CITY OF ALBUQUERQUE

**RE: Crossroads Church
5200 Marble Ave. NE
Grading and Drainage Plan
Engineer's Stamp Date: 05/24/19
Hydrology File: J17D035**

DRAINAGE AND TRANSPORTATION INFORMATION SHEET (REV 6/2018)

GRADING & DRAINAGE PLAN

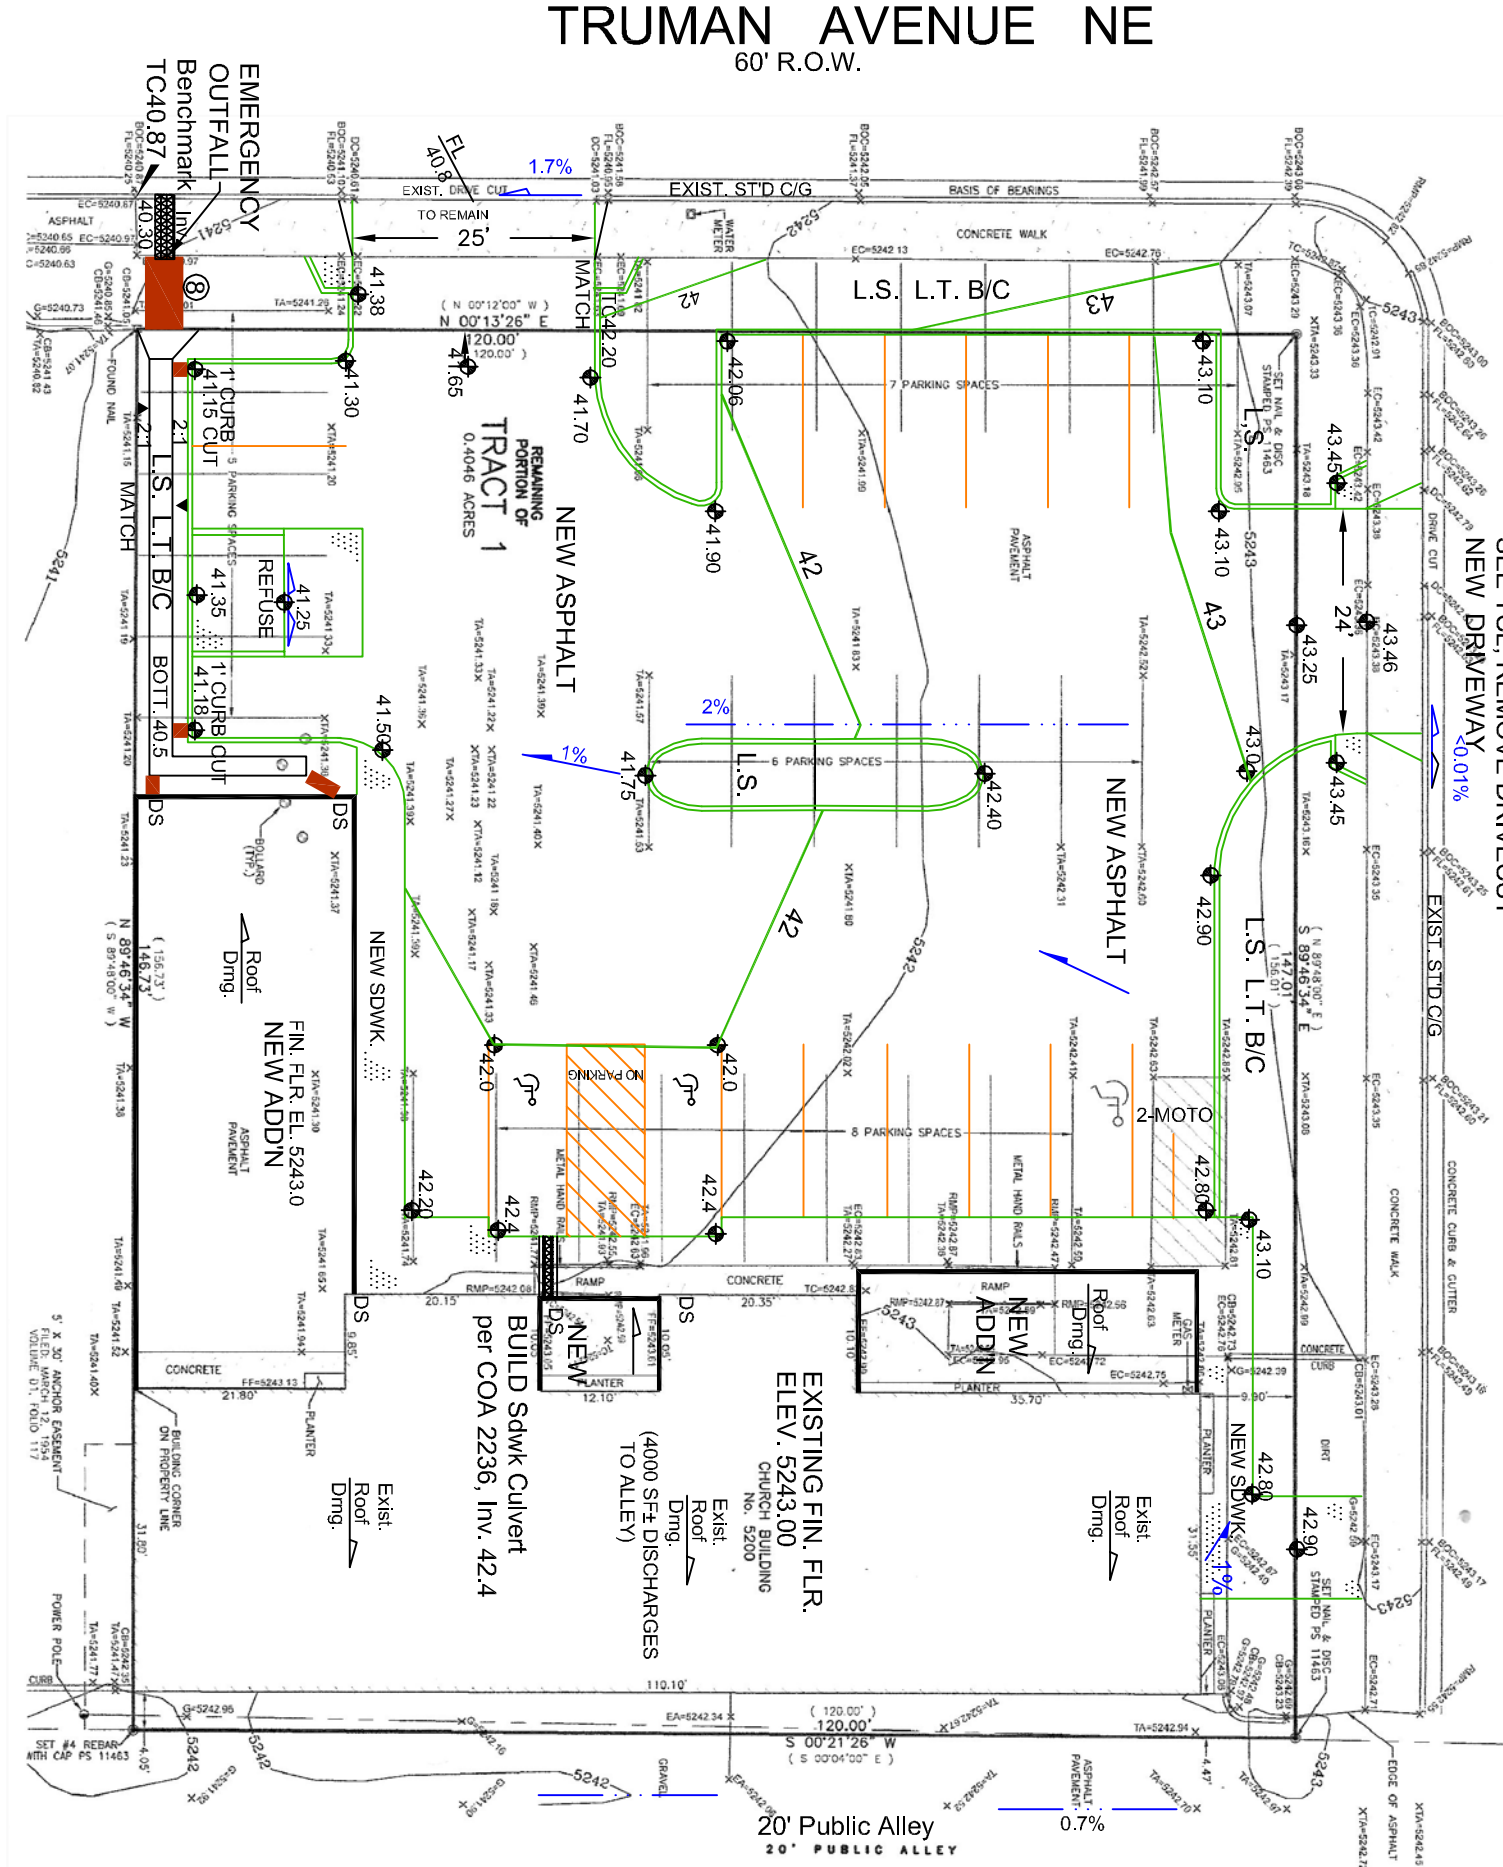
Based upon the information provided in your submittal received 05/24/2019, the Grading and Drainage Plan is approved for Building Permit and SO-19 Permit.

Also as a reminder, please provide Drainage Covenant for the retention pond per Chapter 17 of the DPM prior to Permanent Release of Occupancy. Please submit this on the 4th floor of Plaza de Sol. A \$25 fee will be required.
